BOARD ACTION REPORT – APPEALABLE ITEM

Project Name: The Grove

Request: Class III Site Plan Modification

ITEM: **The Grove (2016-254):** Class III Site Plan Modification for **The Grove** (aka The Esplanade at The Grove) associated with modifications to the existing site plan, landscape plan and architectural elevations to accommodate a building expansion, use conversion, and external renovations to the existing facades.

EXISTING SITE PLAN

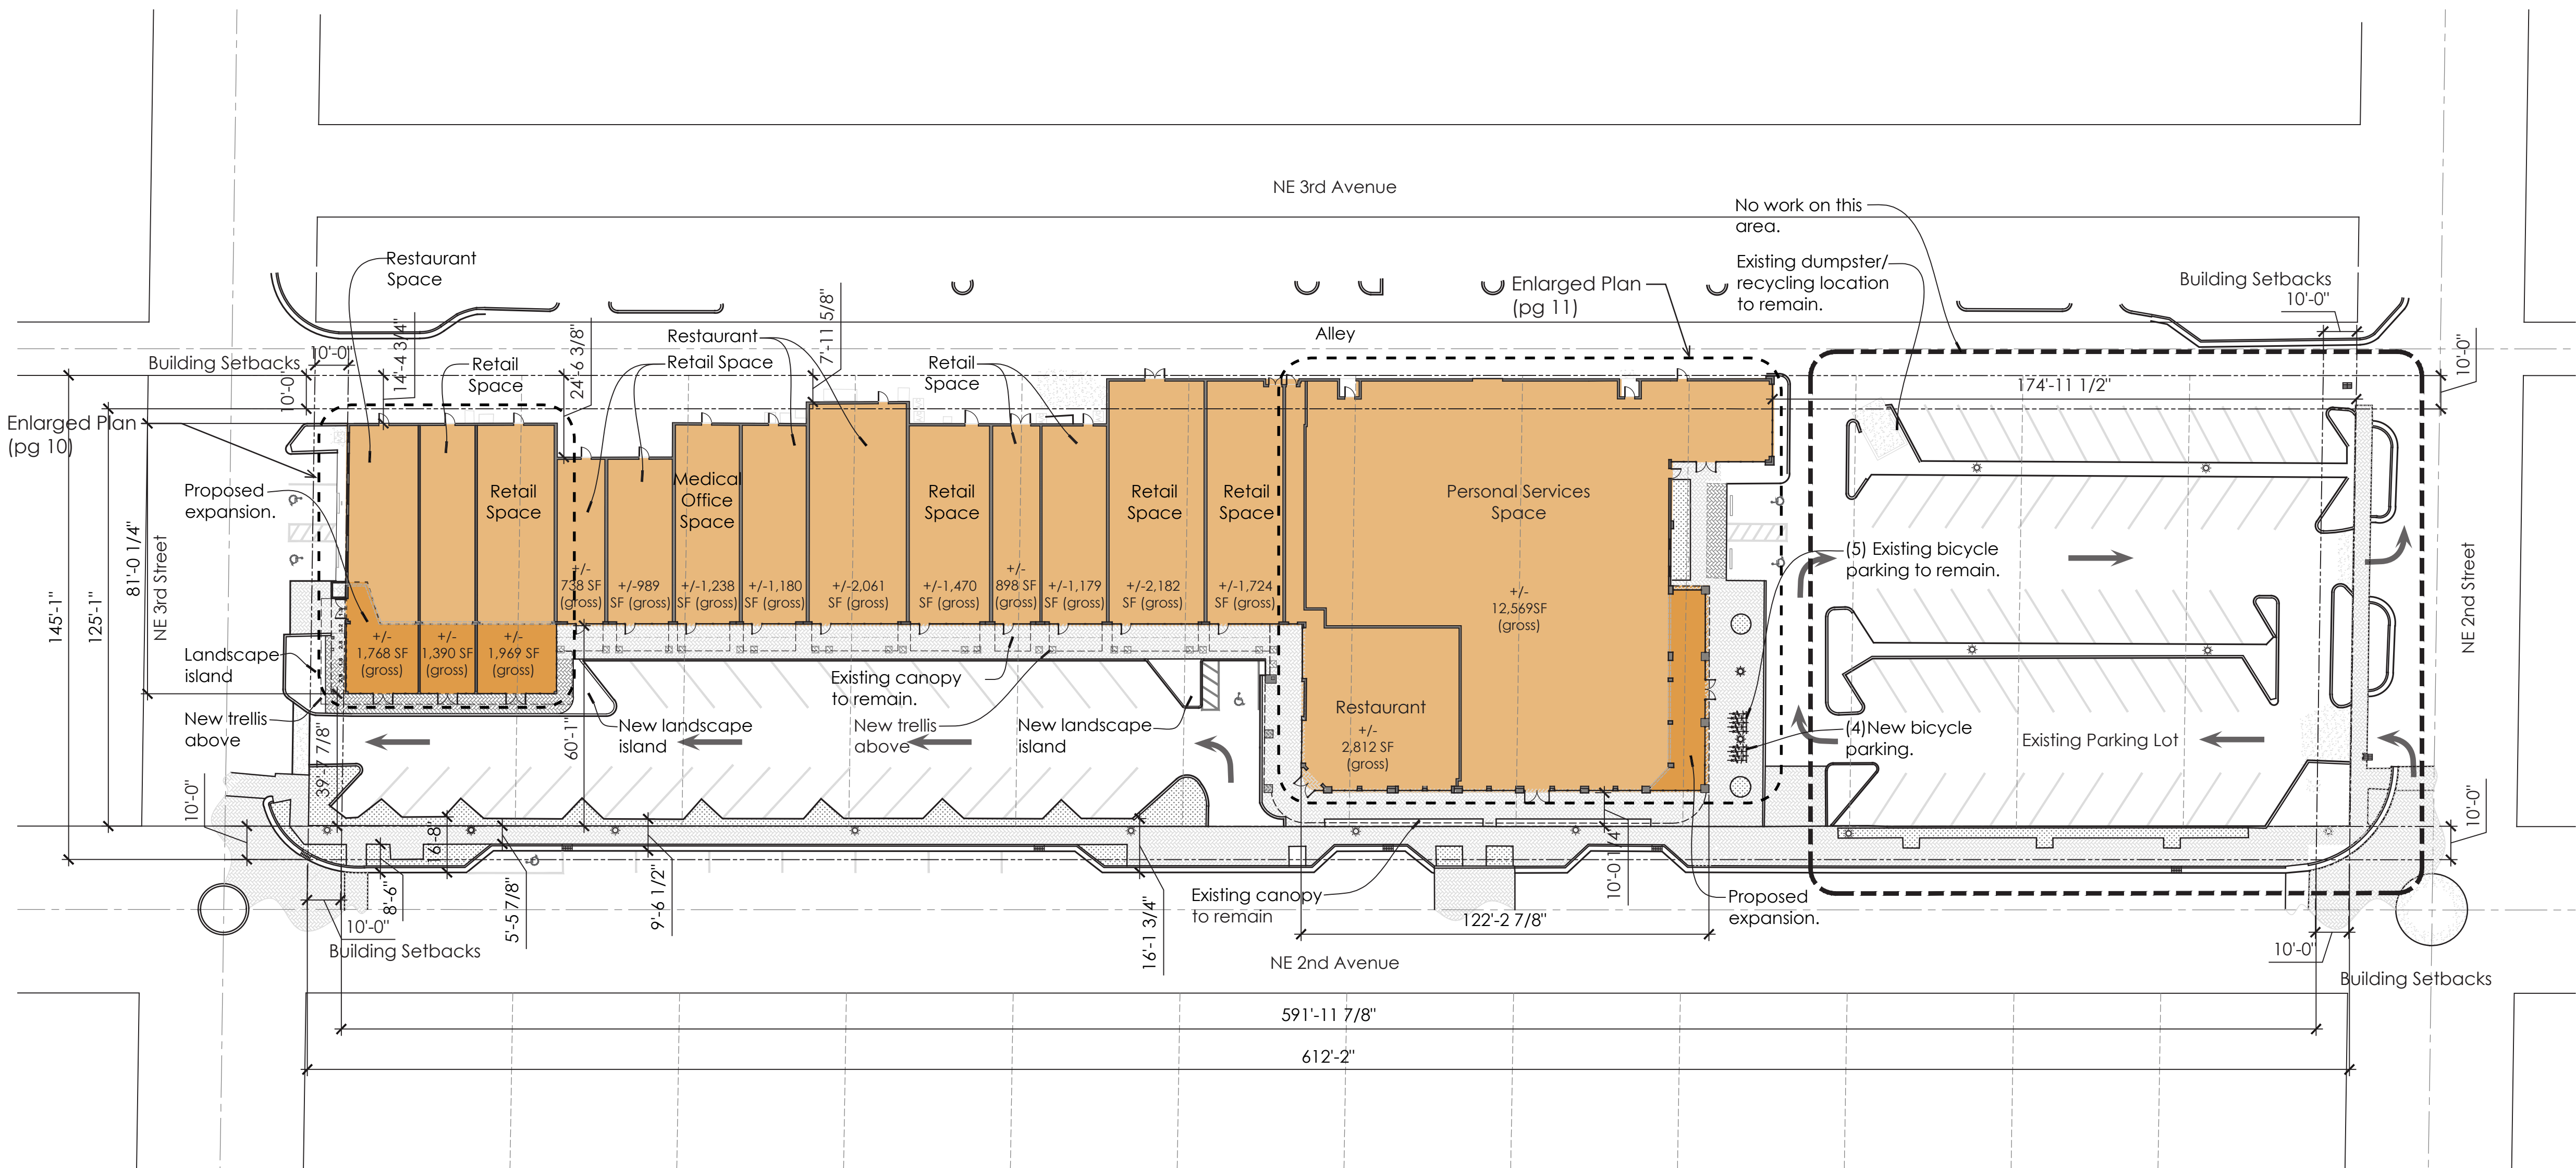
1. That a vision obscuring gate be installed on the fourth side to screen the existing dumpster;

Pursuant to LDR Section 4.6.6(C)(1), dumpsters, recycling containers and similar service areas must be enclosed on three sides with vision obscuring gates on the fourth side, unless such areas are not visible from any adjacent public right-of-way. The existing dumpster is located on the south parking lot area. The existing dumpster is enclosed on three sides and screened with landscaping on two sides. There is no gate on the fourth side, and it can be visible from the alley. Although, the existing condition is a legal non-conformity, it is recommended that a vision obscuring gate be installed on the fourth side to screen it.

Existing dumpster to remain. Recommendation of a vision obstructing gate be installed on the fourth side won't be acted upon.
